UZBEKISTAN GAS TO LIQUID PROJECT (UZGTL)

HAZOP ACTION CLOSE-OUT REGISTER FOR MAKE-UP H2 COMPRESSOR PACKAGE

UZGTL-HDC-HSE-RP-50-0-0004

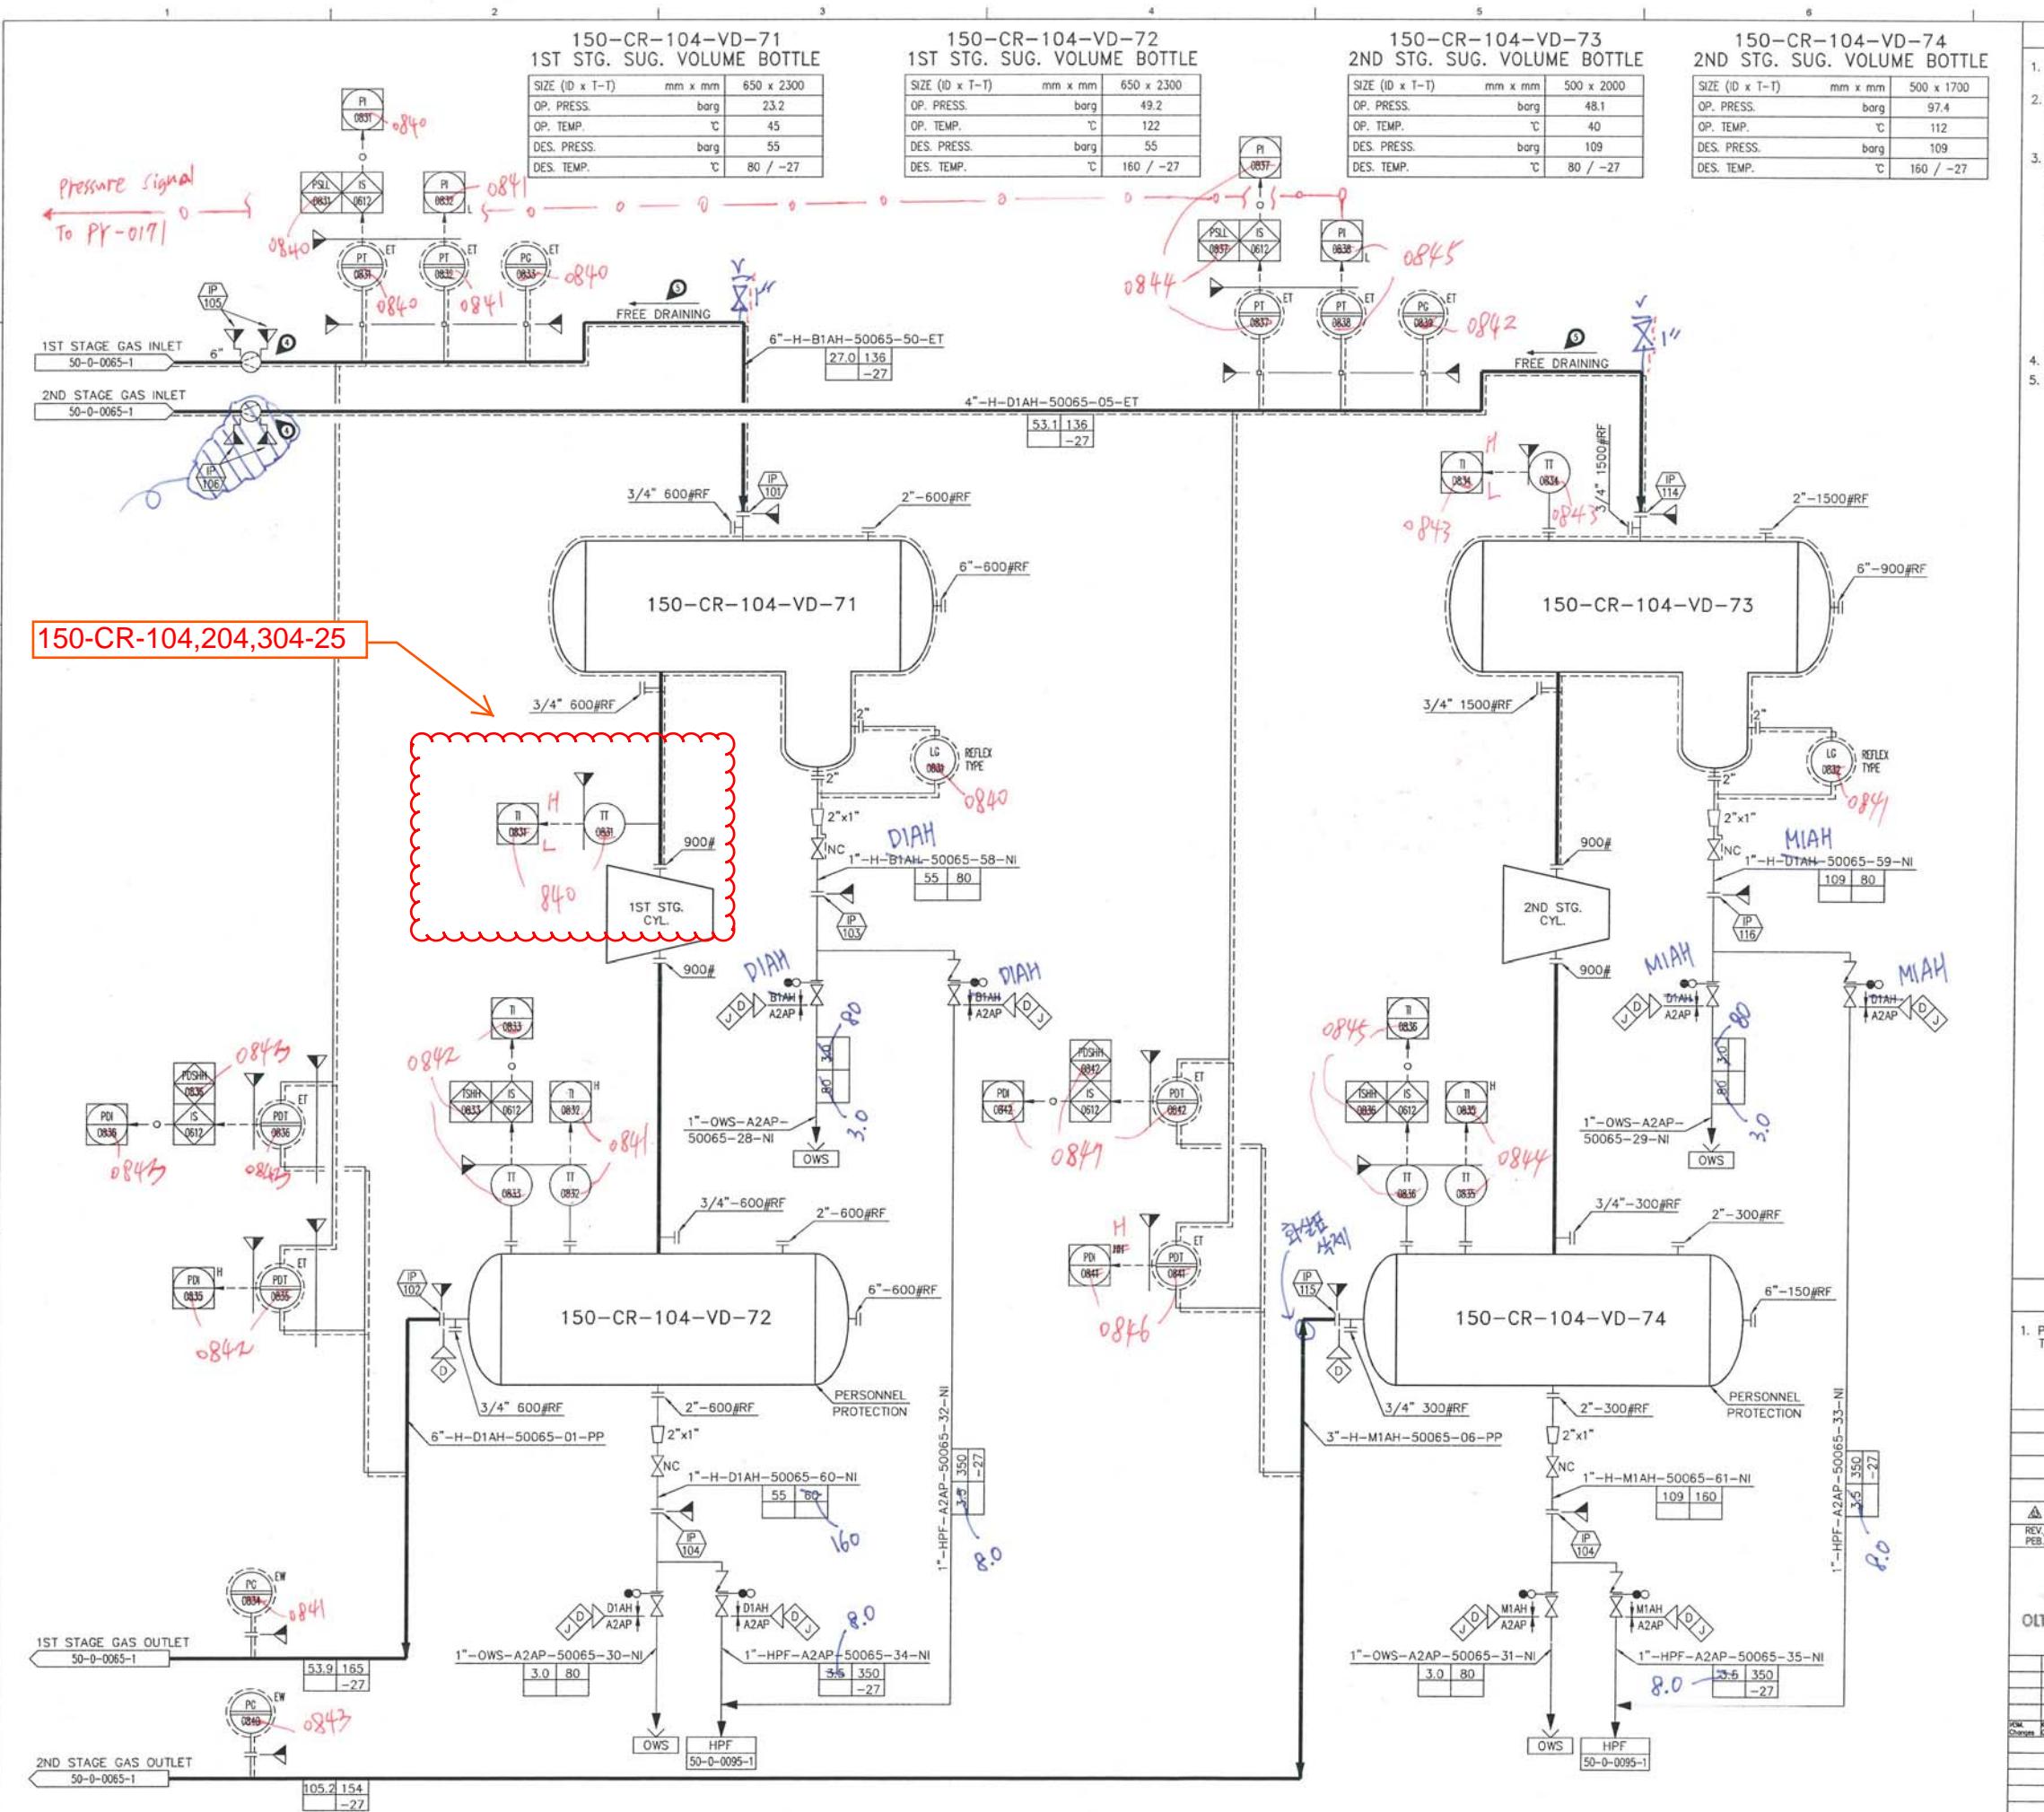
Action No.	150-CR-104/204/304-25				
Action By	PR				
Node No.	1				
Node Description	1. Compressor Process Gas / Compressor Vent & Drain / Compressor Unloader				
Cause	1.8.2. More Temperature of process gas from upstream (Refer to Unit 50 Process HAZOP) 1.9.1. Less Temperature of process gas from upstream (Refer to Unit 50 Process HAZOP) 1.9.2. Low ambient temperature (Refer to Unit 50 Process HAZOP)				
Consequence	1.8.2.2. Gas density decrease leading to gas mass flow rate decrease. No significant consequence. 1.9.1.1. Gas density increase leading to gas mass flow rate increase resulting in potential high pressure and compressor overload 1.9.2.1. Gas density increase leading to gas mass flow rate increase resulting in potential high pressure and compressor overload				
Safeguards	1.9.1.1.1. Motor overload protection 1.9.2.1.1. Motor overload protection				
Action	Provide High/Low Temperature Alarm on 150-TI-0831A on DCS

Response	Incorporated on P&ID (50-0-0065/66/67-2). High/Low temperature alarm on 150-TI-0831 on DCS will be provided. (Please refer to attached P&ID, UZGTL-HDC-PRO-07-50-0-0065/66/67-2)				
CONTRACTOR			OWNER		
Position	Signature	Date	Position	Signature	Date
Process Engineer	<u>B.M.Hwang</u> 	10-Apr-2018		_____
